# NORTHGATE PHASE 1 Drainage Plan

RE: Northgate Phase 1 - Drainage Report and Plan

Re: Conditions of approval for Northgate Phase 1 Drainage Report:

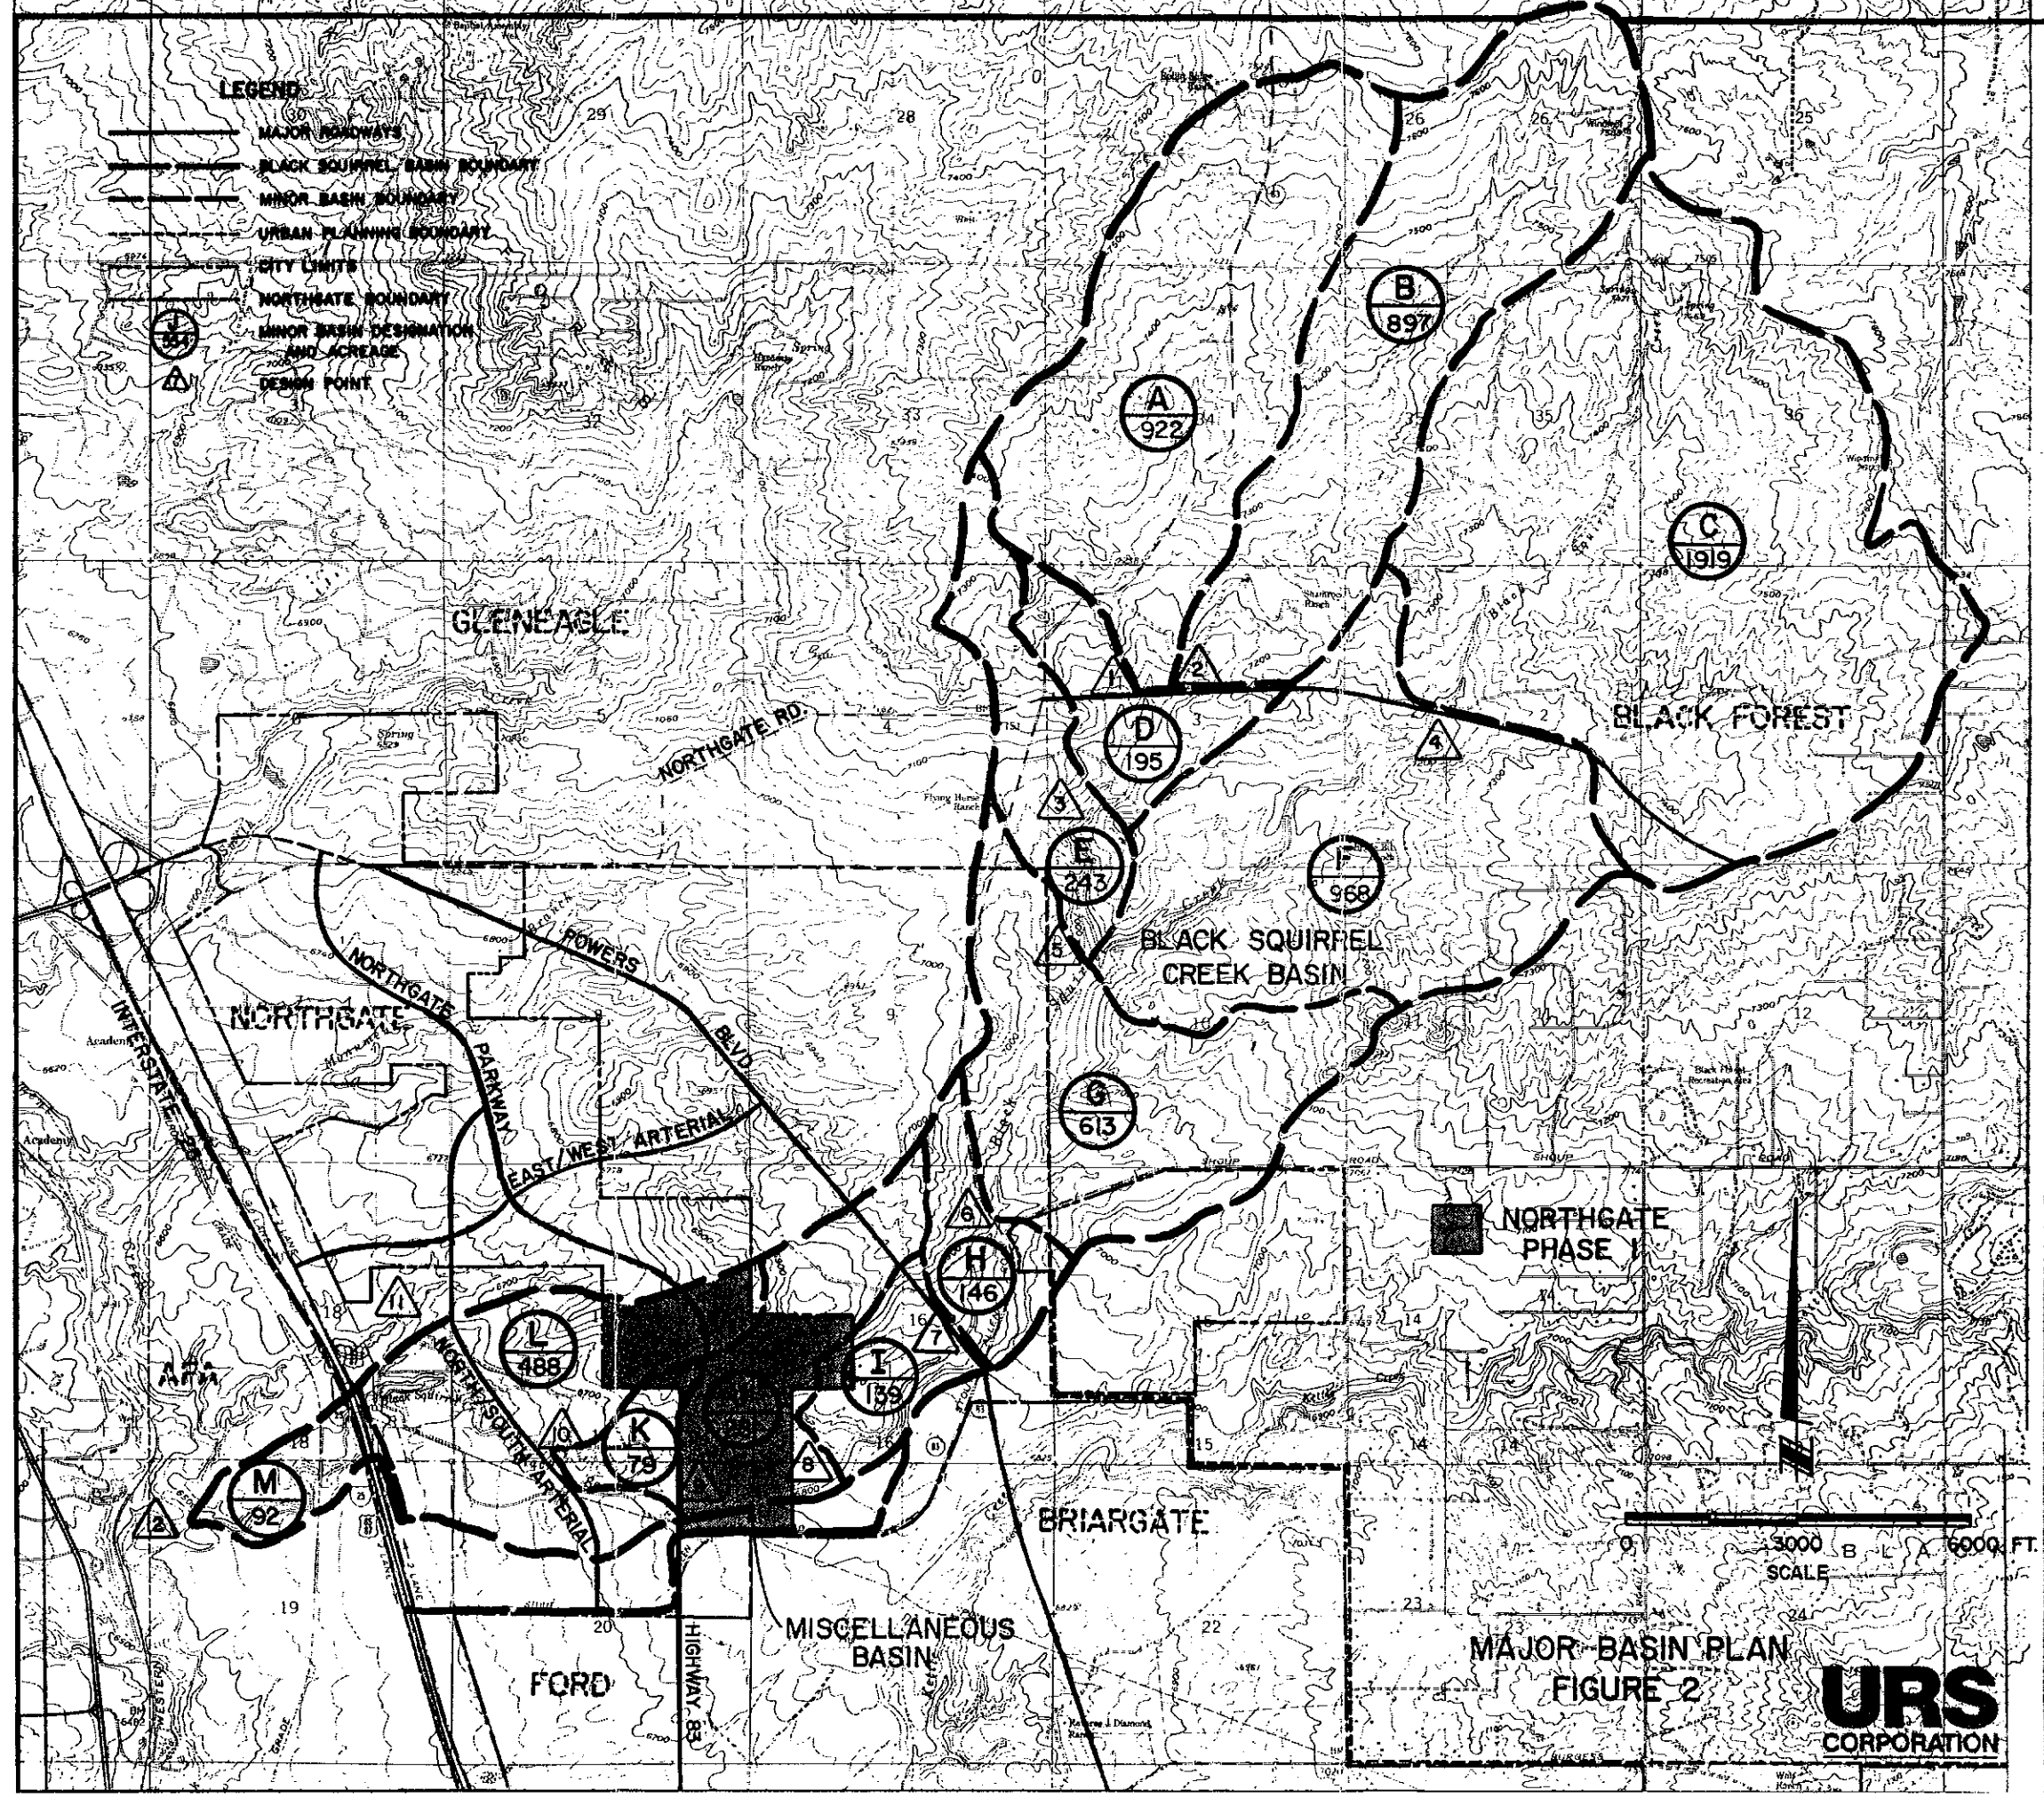
1. This Drainage Report filed for rough-cut and drainage facility construction only as shown on Figure No. 1 (Northgate Parkway and Loop Road). No curb, gutter walks or street pavement construction will be allowed until this report is resubmitted with an analysis of site drainage and detention facilities.

6. No additional public detention facilities will be allowed in the miscellaneous basin shown on Figure No. 1. Sizing of outfall facilities will be subject to private detention facility requirements.
